## TECHNICAL MEMORANDUM

<b>To</b>	Tom Bird (GCC), Sarah Vance (GCC)	<b>Ref #</b>	2018-05-035-TM-1
<b>CC</b>		<b>Date</b>	2/13/2020
<b>From</b>	Landon Beck		
<b>Subject</b>	Response to 2018 King Coal Mine AHR DRMS Review dated January 2, 2020

**Figure 1. pH vs SC (surrogate for total dissolved solids) in some surface waters and alluvial wells**

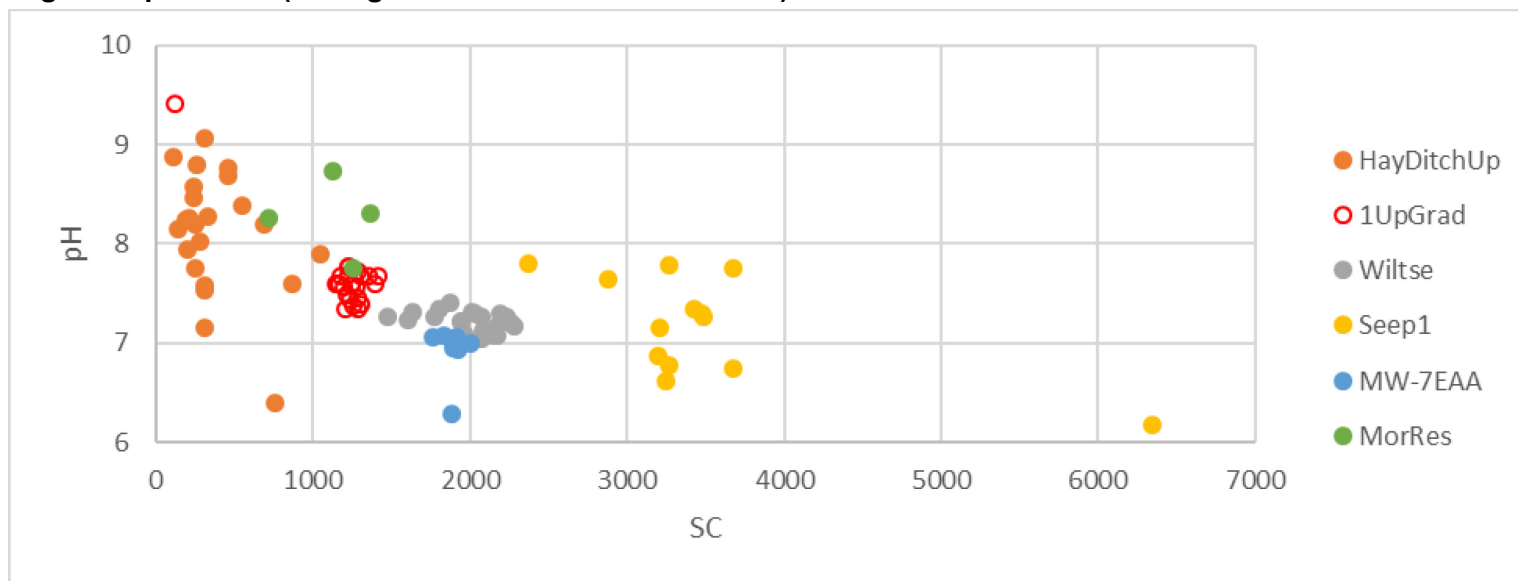
The following two plots, made during assessment of the monitoring data but not included in the AHR, show some relations between pH and total solutes (represented by SC). It can be seen the Animas River water in the Hay Ditch has widely variable pH and low SC, and the low SC may actually lend some of the pH variability through sensitivity which comes in dilute water with lack of buffering. Alluvial wells (1UpGrad = Well #1 Upgradient, Wiltse, MW-7-EAA) and Seep-1

generally have pH less than 8, though the Mormon Reservoir (MorRes) ranges between 8 and 9. Several bedrock wells, particularly in the deeper and less permeable Menefee floor designated Menefee Interburden (MW-4-MI, MW-5-MI, MW-6-MI) , have elevated pH, which might be due to hydrolysis of shale clays. Such hydrolysis is common, and may be represented as sodic clay +  $H^+$  +  $H_2O$  yielding aluminosilicate + silicic acid +  $Na^+$ . The effect of such hydrolysis on pH is limited by the availability of  $H^+$  in the first place.

**Figure 2. pH vs SC (surrogate for total dissolved solids) in bedrock wells**

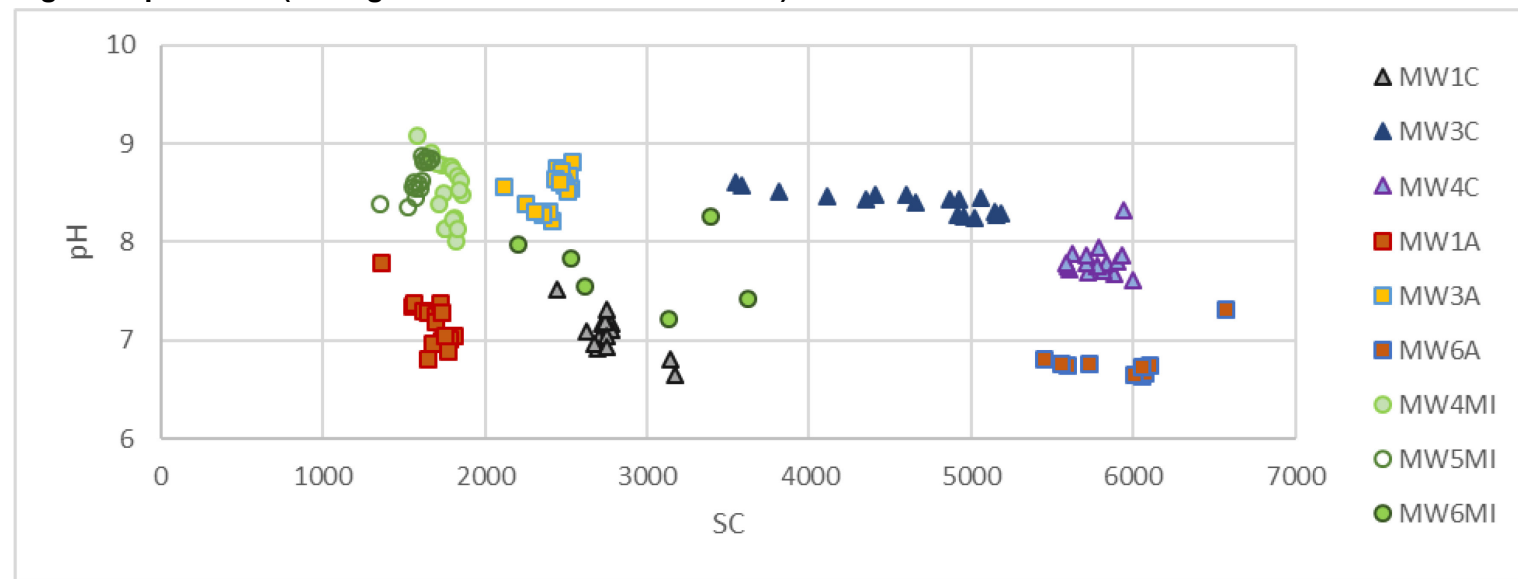
Clearly each of these monitoring wells shows a discrete pattern, reflecting local rock-water interaction rather than some homogeneous entity (or entities). These figures do not show any sort of flow path evolution. If one compares pH and SC at coal wells MW-1-A (upgradient of the mine) and MW-3-A (downgradient, the differences would be better explained as lower TDS in MW-1-A due to shorter infiltration path, and longer path to MW-3-A dissolving more solutes and hydrolyzing more clay, than through some impact by the dry intervening mine.
